Clause 23 Request Tracking Table

Site / Project	Pukekohekohe Gateway Plan Change
----------------	----------------------------------

In addition to the responses provided in the 'Applicant Response' column of the below table, the following attachments support the response to Auckland Council's Further Information Request under Clause 23 of the First Schedule to the Resource Management Act 1991 (RMA), dated 17 June 2025 on behalf of Auckland Thoroughbred Racing Inc. (ATR):

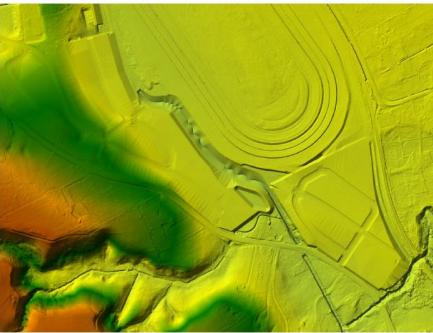
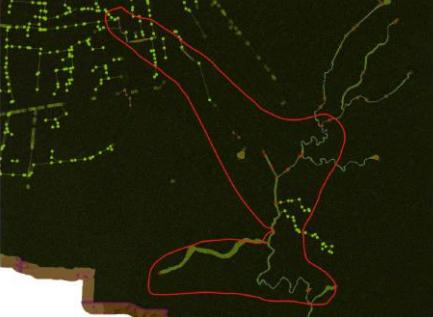
SW2 - Flooding	The proposed imperviousness in the PPC area is not reflected in the flood model for the subcatchments affected	This information is required to enable a full assessment of any actual and/or potential flood effects.	The pre and post development modelling is undertaken based on permitted imperviousness for - Special Purpose - Major Recreation Facility Zone (80%). The expected

Reference / Category of Information	Specific Clause 23 Request	Reason for Request	Applicant Response
	<p>under the post development scenario. Increased imperviousness can impact peak flows.</p> <p>Please review the subcatchments boundary in relation to the proposed terrain changes and update the flood model accordingly.</p>		<p>imperviousness for residential development enabled by the Plan Change is lower than the currently permitted allowances for the Special Purpose – Major Recreation Facility zone (down to approximately 60%).</p> <p>Sensitivity undertaken with pre-development set to existing imperviousness (greenfield in general) and shown below. There are no increases upstream or downstream on third-party land.</p> 
SW3 - Flooding	<p>Change of roughness value can impact flood depth.</p> <p>For the post-development scenario, the roughness value (i.e. Manning's n value) for the roughness zones in the model should reflect the proposed land use changes in the PPC area, including proposed planting in the naturalised</p>	<p>This information is required to enable a full assessment of any actual and/or potential flood effects.</p>	<p>Changes have been incorporated into the model, including a roughness value of Manning's 0.1 for private lots and 0.02 for roads and impervious surfaces.</p> <p>A composite Manning's n value of 0.10 has been adopted for the diversion channel/stream to account for the representative roughness of a low-flow channel ($n \approx 0.04$) and densely vegetated banks/floodplain ($n \approx 0.12$), consistent with the ranges given in Chow (1959) and</p>

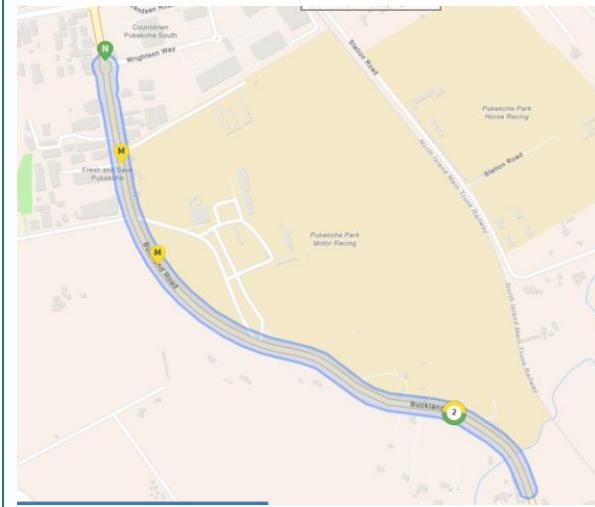
SW8	<p>Please compare the post and pre development terrain data and advise changes in flood storage in a 1%AEP CC 3.8 scenario i.e. loss or gain in flood storage volume within the PPC area.</p> <p>PPC Terrain (Post Development)</p>  <p>Existing Terrain (Pre Development)</p> 	<p>This information is required to enable a full assessment of any actual and/or potential flood effects.</p>	<p>Noted. The flood storage for 100yr 2.1C within the site is calculated for pre and post development scenarios.</p> <p>Pre-development - 245,000m³</p> <p>Post development flood storage - 205,000m³</p> <p>Stormwater tanks - between 5000m³ depending on the number of lots. (potential lots - 450-600)</p> <p>Pond - approx. 1,000m³</p> <p>Total post development storage - 211,000m³</p>

Reference / Category of Information	Specific Clause 23 Request	Reason for Request	Applicant Response
	 Terrain differences 		
SW9 – Flooding	<p>Please present and assess the model run for the 10yr existing rainfall for the pre and post development scenarios and the 10yr with 3.8 climate change for the pre and post development scenarios.</p>	<p>This information is required to enable a full assessment of any actual and/or potential flood effects.</p>	<p>Provided. Review closed and model results accepted as of 28/07/2025</p>
SW10 Flooding	<p>Please present and convert the flood model results e.g. the maximum flood depths to ASC raster files and a post-pre</p>	<p>This information is required to enable a full assessment of any actual and/or potential flood effects.</p>	<p>Provided. Review closed and model results accepted as of 28/07/2025</p>

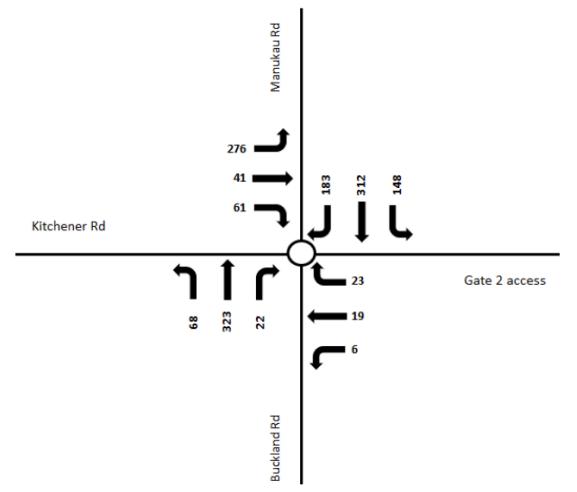
T2 – ITA	<p>Please provide an assessment of the accessibility of the plan change area for pedestrians and cyclists to key destinations (such as employment, schools, supermarkets, train station etc.), including the provision of drawings showing isochrones for the</p>	<p>The assessment is required to better understand how the plan change is accessible for active mode users to key destinations</p>	<p>An Isochrone Analysis has been prepared, providing an assessment of the accessibility of the plan change area for pedestrians and cyclists to key destinations, and is included at Appendix 7. The key destinations assessed included education facilities, open spaces and reserves, employment opportunities in the surrounding Business and Industrial Zones, Franklin Hospital, Pukekohe Train Station, and the Woolworths Supermarket on Manukau</p>

Reference / Category of Information	Specific Clause 23 Request	Reason for Request	Applicant Response
	area accessible for pedestrians and for cyclists.		Road. As illustrated, it is considered that overall, the Plan Change area has good levels of accessibility to these surroundings amenities and facilities.
T3 – ITA	Details are required to assess whether the trip rates used are representative of the subject site and to confirm how the average trip generation rate has been derived.	Details are required to assess whether the trip rates used are representative of the subject site and to confirm how the average trip generation rate has been derived.	<p>As described in Section 6.2 of the ITA, the trip rates are sourced from the average of those provided in the Institute of Transportation Engineers Trip Generation Manual (ITE Manual), and the RTA Guide to Traffic Generating Developments (RMS document), and a traffic survey from an existing residential development located in Auckland.</p> <p>The survey data was derived from a Beachlands North survey that was considered comparable to the subject site and was associated with the 'low density' trip rate. Using the aforementioned industry accepted guidelines and the Beachlands North survey, the 'low' density trip rate was averaged between the three sources to provide an AM rate of 0.8 and a PM rate of 0.83 per low density dwelling.</p> <p>The 'medium density' trip rate was derived solely from the RTA Guide, noting that the ITE provided a lower rate of 0.46 per medium density dwelling in the AM and 0.56 per medium density dwelling in the PM.</p> <p>It is important to note that all of the trip generation data referenced predates the COVID-19 pandemic. Since then, remote and hybrid working patterns have become more prevalent, and no contemporary trip generation data is currently available that reflects these behavioural</p>

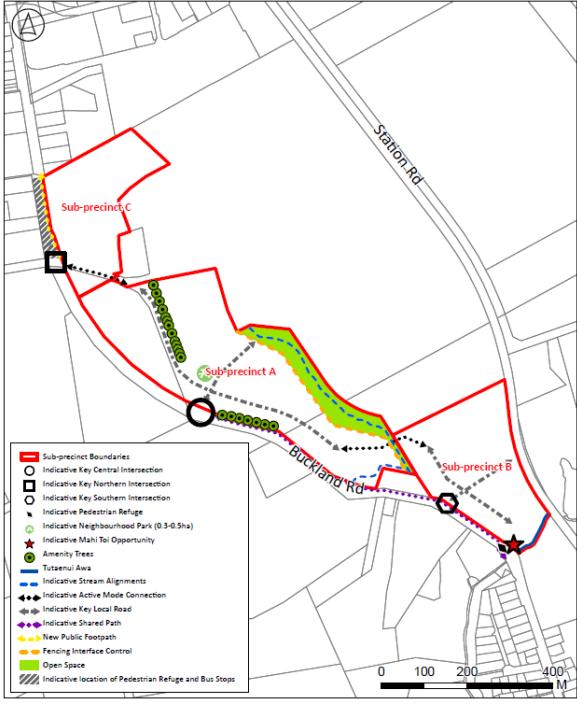
T10 – ITA	<p>Please provide an assessment of the chosen location of the southern key intersection into Sub-precinct B that demonstrates that the location is safe, has appropriate visibility and that the road is suitable for the proposed intersection (including any widening for the right turn bay).</p> <p>This should take into account the existing and anticipated future speed limit on Buckland Road.</p>	<p>The assessment is required to confirm that there is a safe feasible location for the proposed southern key intersection into Sub-precinct B. There is no certainty as to when, if at all, the speed limit on Buckland Road will be reduced from 80km/h to 50km/h, therefore, the intersection will need to be designed to operate safely for both posted speed limits.</p>	<p>The southern key intersection to Sub-precinct B is proposed to form a T-intersection. Austroads: Guide to Road Design Part 3: Geometric Design (Austroads) has been used to determine an appropriate sight distance. The site is located within the signposted 80km/h speed limit area. It is noted that the location of the access is around 200m west of the 50km/h speed limit and therefore drivers will be preparing to slow down on approach.</p> <p>For comparison, the requirements for an 80km/h speed environment and a 50km/h speed environment have been undertaken.</p> <p>Buckland Road is relatively flat and a driver's eye height is 1.1m and the top of a vehicle being 1.25m.</p>

Reference / Category of Information	Specific Clause 23 Request	Reason for Request	Applicant Response
			<p>This equates to a Safe Intersection Sight Distance (SISD) requirement of 181.1m under an 80km/h operating speed environment and 96.8m under an 50km/h operating speed environment.</p> <p>The available sight distance to the west is 268.5m and to the east is 187.8m. Therefore, the SISD complies under both scenarios.</p>
T11 – ITA	<p>Please provide concept layouts of the intersections at:</p> <p>a) Kitchener Road / Buckland Road / Manukau Road / Sub-precinct C; and</p> <p>b) Buckland Road / PC87 / Sub-precinct A.</p> <p>The layouts should take into account the existing and anticipated future speed limit on Buckland Road.</p>	<p>The layouts are required to:</p> <p>a) confirm that the proposed form of intersections are feasible; and</p> <p>b) Confirm that the modelled arrangements for the intersections match the anticipated form of the intersections (noting that the geometry of the intersections affects capacity).</p> <p>It is acknowledged that the intersections will be subject to detailed design. However, some concept design is required to confirm that the intersections are feasible and whether the intersections can be formed within the available land.</p>	<p>For information purposes, a concept design of the proposed roundabout is provided as Appendix 9.</p>

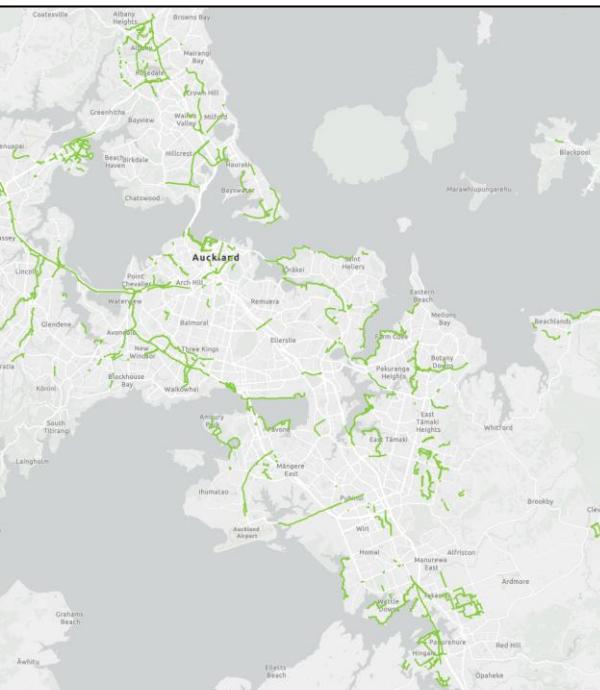
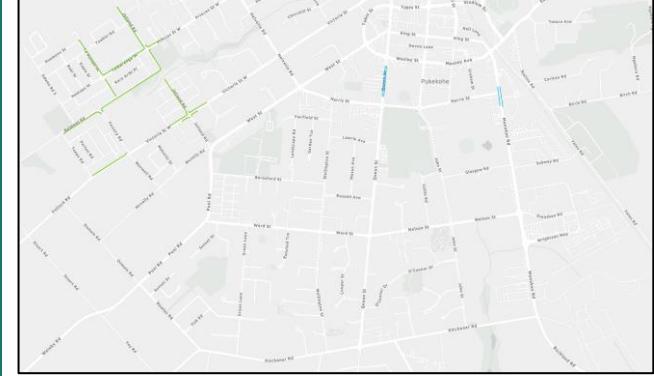
T12 – ITA	<p>Please demonstrate that it would be feasible to provide a roundabout for the central key intersection should development with the proposed plan change proceed ahead of development of PC87.</p>	<p>This information is required to understand whether the access into Sub-precinct A can be established in accordance with the proposed Precinct Provisions in advance of PC87</p>	<p>For information purposes, and to demonstrate the feasibility of a roundabout at this location, a concept design of the proposed roundabout is provided as Appendix 9.</p> <p>The fourth arm on the southwestern arm can feed into the existing driveway at that location should the subject</p>

Reference / Category of Information	Specific Clause 23 Request	Reason for Request	Applicant Response
			<p>PPC site proceed ahead of PC87. No third-party land is required in the design.</p> <p>Further, Part IX.8.2 (f) (Assessment Criteria) within the proposed Pukekohekohe Gateway Precinct Provisions states:</p> <p><i>Where an interim upgrade is proposed the design allows for the ultimate upgrade to be efficiently delivered.</i></p> <p>That provision ensures that the roundabout will be able to accommodate the connection to PC87 once it is made.</p>
T13 – ITA	<p>Please provide an assessment that demonstrates that the refuge island crossing for pedestrians and cyclists on Buckland Road at the southern end of the plan change can be provided safely (including a visibility assessment), and key dimensions that show that the refuge if feasible and can be provided within the available carriageway width.</p> <p>The assessment should take into account the existing and anticipated future speed limit on Buckland Road.</p>	<p>The assessment is required to demonstrate that it is feasible to provide a safe refuge island crossing facility. The crossing facility will need to accommodate both pedestrians and cyclists to enable northbound Buckland Road cyclists to cross to the shared path on the eastern side of Buckland Road.</p>	<p>There are 2 key sight distance requirements at pedestrian crossing facilities: Crossing Sight Distance (CSD) and Approach Sight Distance (ASD).</p> <p>CSD is based on the stopping sight distance required for a driver to perceive a hazard (such as a pedestrian in a refuge island), react, and safely stop and is documented in Section 3.3 of Austroads Guide to Road Design Part 4A: Unsignalised and Signalised Intersections.</p> <p>This was assessed at the 80km/h speed environment and a 50km/h speed environment, a walking speed of 1.2 m/s and a crossing length of 3.6m (kerb to island) and 1.5m pedestrian set back from the road (total crossing distance = 5.1m). The crossing distance to the island is</p>

Reference / Category of Information	Specific Clause 23 Request	Reason for Request	Applicant Response
			<p>included in the assessment as the island provides a suitable refuge for a pedestrian to stop and wait for a suitable gap in the adjacent traffic lane.</p> <p>$CSD = t*V/3.6$</p> <p>CSD = 94.4m in an 80km/h operating speed environment.</p> <p>There is 223.3m between southbound vehicle and pedestrian and 105.9m from northbound vehicle to pedestrian and therefore would comply with the CSD requirement.</p> <p>ASD ensures that approaching drivers are aware of the presence of a pedestrian crossing facility. ASD should be provided at 1.1 eye height and the surface of the roadway (generally 0.m).</p> <p>A reaction time of 2.0 seconds, a coefficient of deceleration of 0.36%, a flat topography and an 80km/h speed environment is adopted at this location.</p>

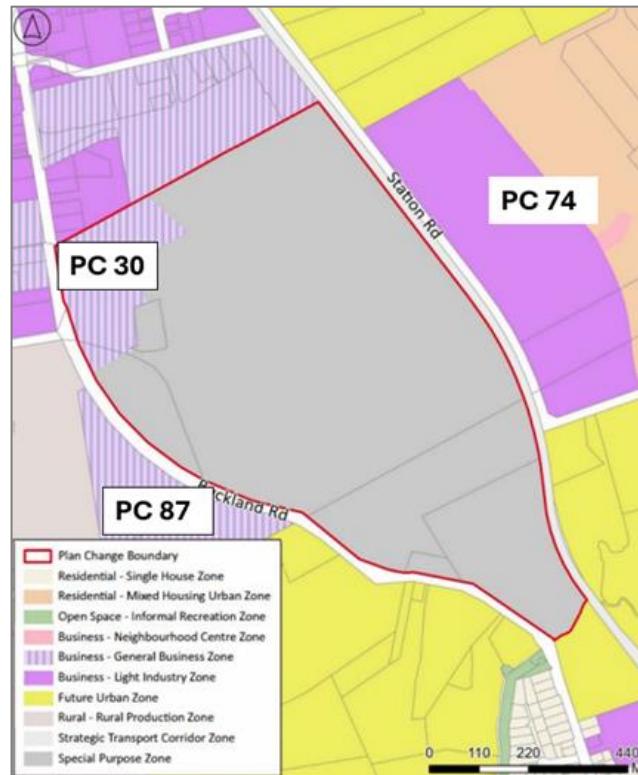
PL4 – Medium Density	As discussed during pre-lodgment consultation, Schedule 1, clause 25(4A) requires the Council must not accept or	This information is required by Schedule 1, clause 25(4A)	The preference is to revisit whether the MDRS need to be incorporated into the Precinct once the clause 23 matters are resolved and prior to the clause 25

Reference / Category of Information	Specific Clause 23 Request	Reason for Request	Applicant Response
Residential Standards	<p>adopt a request if it does not incorporate the MDRS as required by section 77G(1). A proposed amendment to the RMA may mean this is no longer required if that part of Plan Change 78 requiring MDRS be incorporated into every relevant residential zone is withdrawn. The outcome of the RMA Amendment and the Council's decision on MDRS is not known at this time.</p> <p>Please advise whether you wish to put the Council's decision regarding clause 25 on hold until this matter is resolved. Noting that this can be revisited once clause 23 matters are resolved.</p>		<p>recommendation. This is the preferred approach based upon a shared understanding that a proposed amendment to the RMA may mean that this is no longer a requirement.</p>
PL5 – Land covenant (Instrument No 10148071.4)	<p>Land covenant (Instrument No 10148071.4) included in the bundle of certificates of titles grants rights relating to Wastewater Operations (Pukekohe Wastewater Pump Station (WWPS)). Clause 6 references operations that generate noise, odour and visual effects. While this is a covenant between the parties, please advise:</p> <p>a. What consideration has been given to the implications of this covenant on the proposed re-zoning of adjoining land for residential activities.</p>	<p>This information is to assist in understanding the potential for reverse sensitivity on the Pukekohe WWPS and enabling residential development on the adjacent property.</p>	<p>The following comments are made with respect to the covenant under Instrument No. 10148071.4:</p> <ul style="list-style-type: none"> • The boundaries of the proposed Pukekohekohe Gateway Precinct and the indicative key local road layout identified in Precinct Plan 1 will retain sufficient space to incorporate buffers between the Pukekohe WWPS and future residential lots; • The stream located to the north western boundary of the Pukekohe WWPS lot which in addition with proposed Standard IX.6.4, which requires a 10m riparian margin to be planted, will create a buffer at this interface;
